# Access Compliance Report

## Public Rights-of-Way

### (Curb Ramps)

Intersection ID: 1002389	Main Street: DAVID_TAYLOR_DR	Cross Street: N/A	Location: E
ADA ID: 9A4C4E11B652	Ramp Type: Perp	Initial Pass/Fail: Pass	Overall Compliance: No
		Severity Score: 10

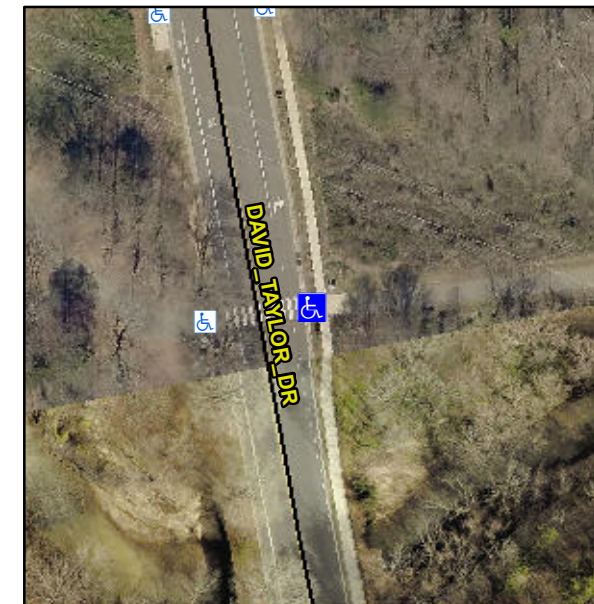
**Not Found, R305.1.4, R302.7.2**

Compliance	Description	Data	Compliance	Description	Data
N/A	Ramp Length (in)	54.0	Yes	Ramp Slope (%)	5.4
Yes	Ramp Width (in)	115.0	Yes	Ramp XSlope (%)	1.2
Yes	Flare Type L	Curbed_NoWalkSurface	Yes	Flare Type RT	N/A
Yes	Flare Slope LT (%)	N/A	N/A	Flare Slope RT (%)	N/A
N/A	Flare Traversable LT?	No	N/A	Flare Traversable RT?	No
Yes	Landing Length (in)	59.0	Yes	DWS Provided?	Yes
Yes	Landing Width (in)	115.0	Yes	DWS Contrast?	Yes
Yes	Landing Slope (%)	1.0	Yes	DWS Length (in)	24.0
Yes	Landing X Slope (%)	0.7	No	DWS Full Width?	No
N/A	Landing Curb? (Y/N)	No	Yes	DWS Offset (in)	0.0
N/A	Shared Landing?	No			
Yes	Gutter Ponding?	No	Yes	Gutter Slope (%)	2.5
No	Gutter Lip Ht (in)	0.5	Yes	Gutter X Slope (%)	0.2
N/A	Painted X Walk1?	Yes	N/A	Painted X Walk2?	N/A
	X Walk 1 Direction	To W		X Walk 2 Direction	N/A
N/A	X Walk 1 Width (in)	131.0	N/A	X Walk 2 Width (in)	N/A
	X Walk 1 Slope (%)	4.5		X Walk 2 Slope (%)	N/A
	X Walk 1 X Slope (%)	1.3		X Walk 2 X Slope (%)	N/A

Yes	Ramp inside XWalk1?	Yes	N/A	Ramp inside XWalk2?	N/A
	Road Slope (%)	N/A	N/A	Clear Space?	Yes
	Road X Slope (%)	N/A	N/A	Clear Space to XWalk (in)	N/A
Yes	Any Obstructions?	No	Yes	Storm Grate/Utility Hazard?	No
	Obstruction Type			Storm Grate/Utility Type	
		N/A			N/A
			Yes	Surface Condition? (G/P)	Good

**Remove & Replace Entire Ramp.**
